INDIANA DEPARTMENT OF TRANSPORTATION

STANDARDS COMMITTEE MEETING

APPROVED MINUTES

RE: Minutes for the April 17, 2008 Standards Committee Meeting

714-BCEX-01 Precast Box Culvert Extension 714-BCEX-02 Extension in Kind for Box Culvert

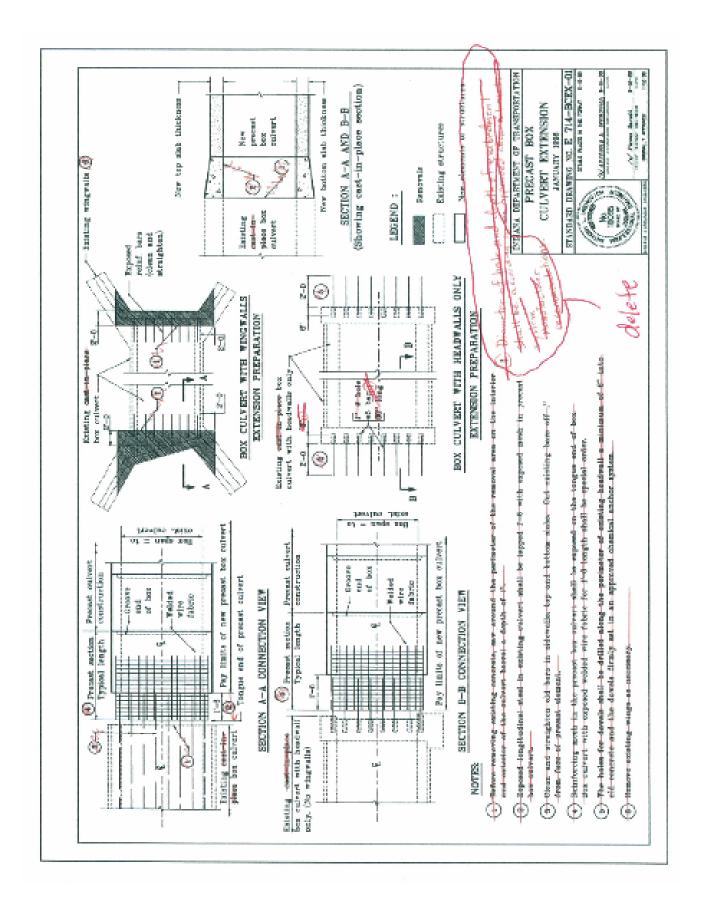
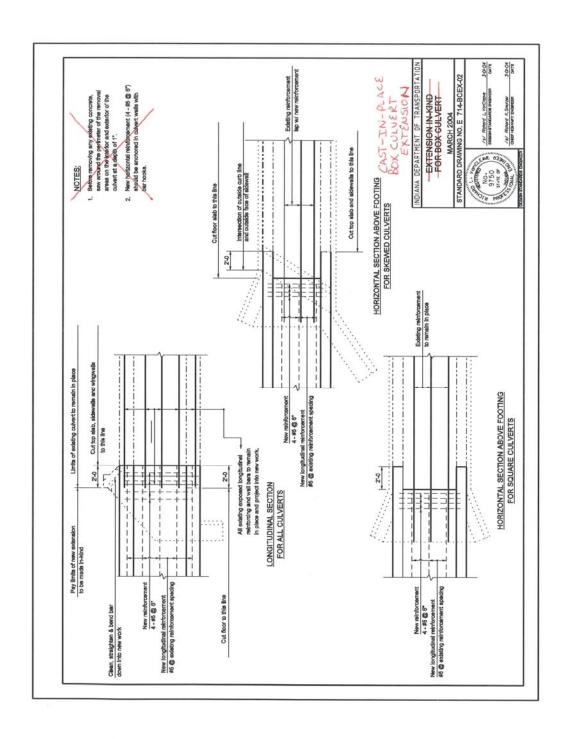
REVISION TO STANDARD DRAWINGS
